**RE: S38 Road Traffic Act 1994,  
Mullinabro Traffic Calming Scheme 2023**

**DATE: 11<sup>th</sup> October 2023**

### **MULLINABRO TRAFFIC CALMING SCHEME 2023**

Project: Mullinahone Traffic Calming  
 Contract: S2018012  
 Title: Plan Layout  
 Drawn By: HB  
 Checked By: NYS  
 Date: 10/04/2024  
 Scale: 1:100  
 Drawing No: ME-LCA-S-01

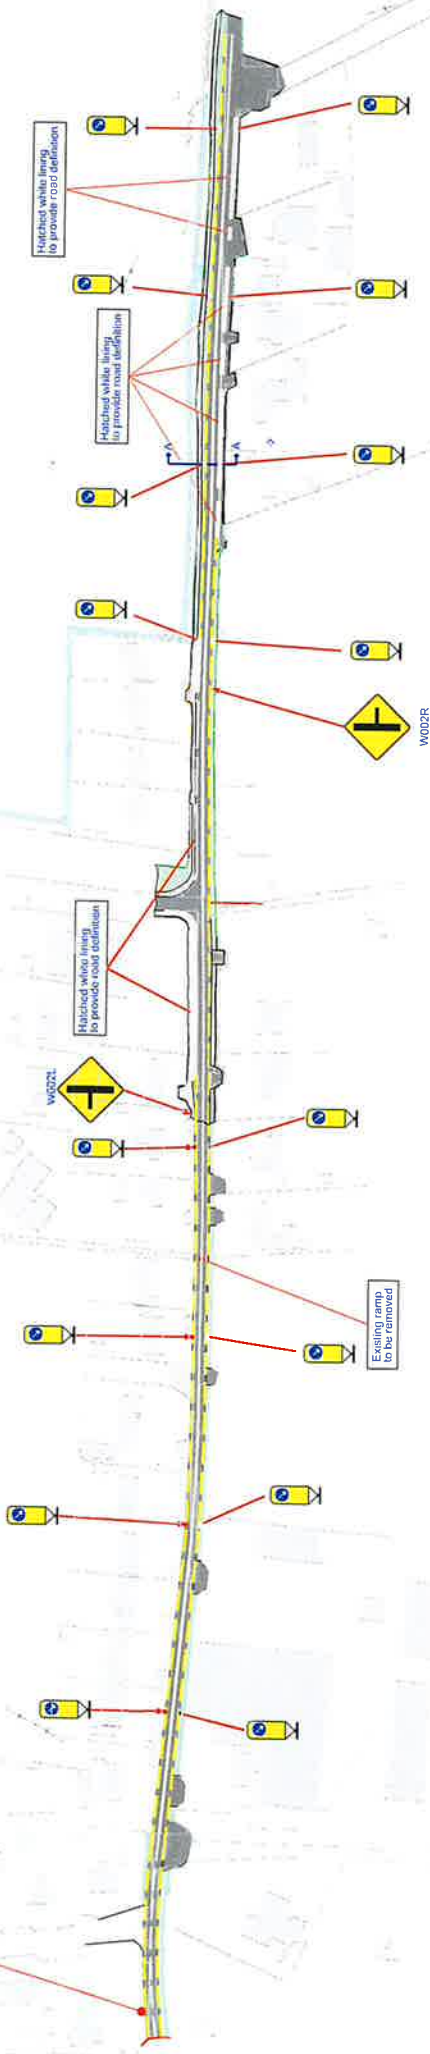
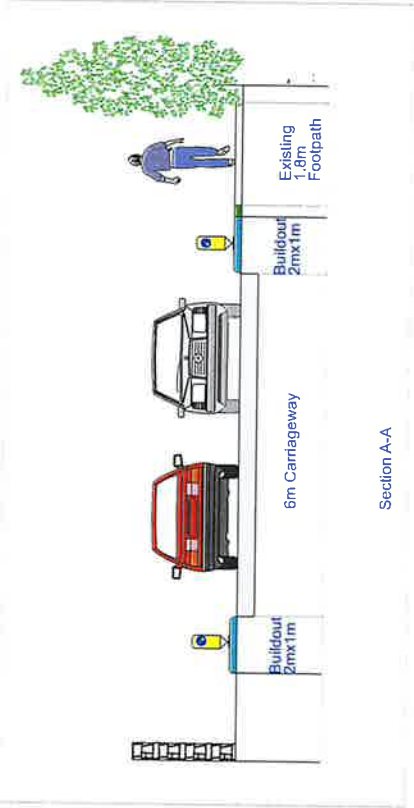
Retain solid centre line, retain existing speed ramp, provide build outs on both sides of the road throughout, extend street lighting

1. The solid white line in the centre of the road should not be removed.
2. The speed ramp at the Cloone Road side of the Mullinabro Road should not be removed because (a) the cost of removing it and reconstituting the road would be money wasted. (b) every possible means should be used on this stretch of road to slow traffic down especially close to the entrance/exit of Mullinabro Woods and outside the houses that front on to the Mullinabro Road.
3. On the town side of the Mullinabro Woods estate entrance/exit there are six outs on the plan to slow traffic down, three on each side of the road opposite each other.

On the Cloone Road side of the Mullinabro Woods estate entrance/exit there are four outs. These outs are only on one side of the road. I believe these outs should be opposite each other and should number six. If only four are to be put in I believe there should be two on each side of the road in a staggered formation as seen in the photo attached. This system works very well in Continental Europe.

The solid white line will be retained to reinforce the efficacy of the traffic calming measures proposed.

The available carriageway width does not provide for full build outs on both sides of the road throughout the scheme. However, smaller buildouts will be provided opposite the build outs on the Cloone Road side of Mullinabro Woods to maintain the narrowing appearance of this part of the road.

- Retain the solid centre line;
- Provide reduced build outs opposite the full-sized build outs on the northern side of Mullinabro Woods;
- Provide advance warning signage for the Mullinabro Woods junction in accordance with the Traffic Signs Manual;
- Provide additional warning signage on Cloone Road following an assessment of suitable signage and locations in accordance with the Traffic Signs Manual.
